# Work Order ID 96484

Item Name: Crosstube Fwd High

DRAWING NO. D212-664-141	TITLE XTUBE ASSY (205/212/412 HI FWD)	REV. D	DART AEROSPACE LTD ENGINEERING ORDER		D.E.O. NO. D212-664-141-D-1	SHEET NO. SHEET 1 OF 2	SCALE NTS
DRAWN	CHECKED	MFG. APPR.	APPROVED	DE APPR.			
DATE 11.04.07	DATE 11.07.11	DATE 11.04.12	DATE 11/04/12	DATE 11.04.12

ADD AN INSPECTION WINDOW TO UNDERSIDE OF CROSSTUBE.

**D212-664-141/-141B**  
**ASSEMBLY DETAIL**

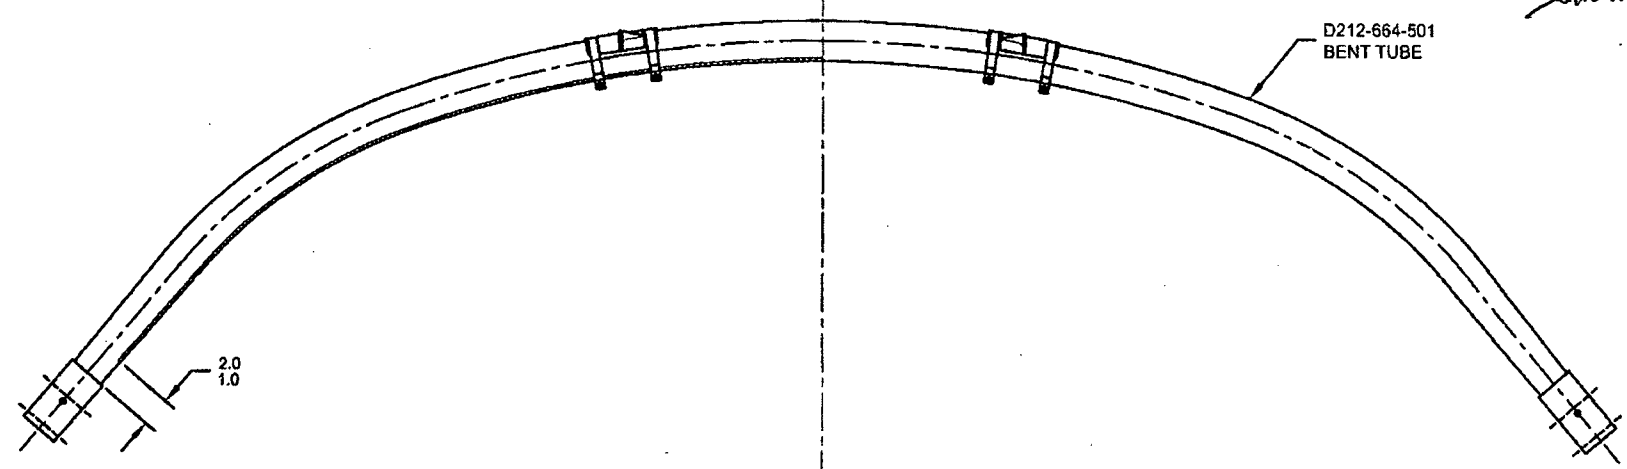
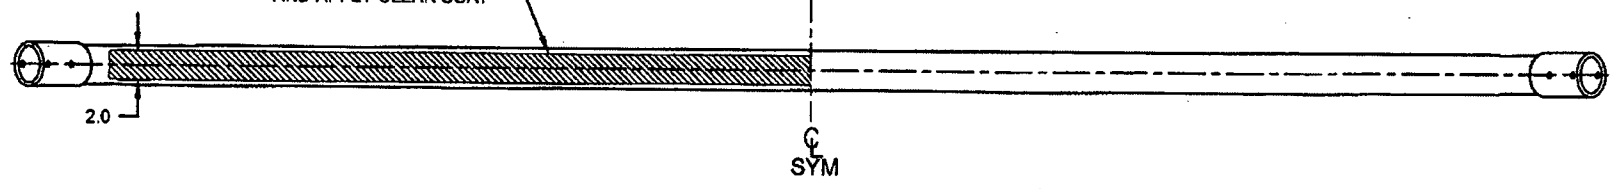
NOTES 2 OF SHEET 1 IS AMENDED AS FOLLOWS:

- 2) FINISH: CHEMICAL CONVERSION COAT PER DART QSI 005 4.1  
PRIME INSIDE AND OUTSIDE PER DART QSI 005 4.2  
MASK UNDERSIDE OF CROSSTUBE AS SHOWN (HATCHED AREA) AND  
PAINT OUTSIDE PER DART QSI 005 4.2  
REMOVE MASKING AND APPLY CLEAR COAT

MASK AREA PRIOR TO PAINTING,  
REMOVE MASKING AFTER PAINT  
AND APPLY CLEAR COAT
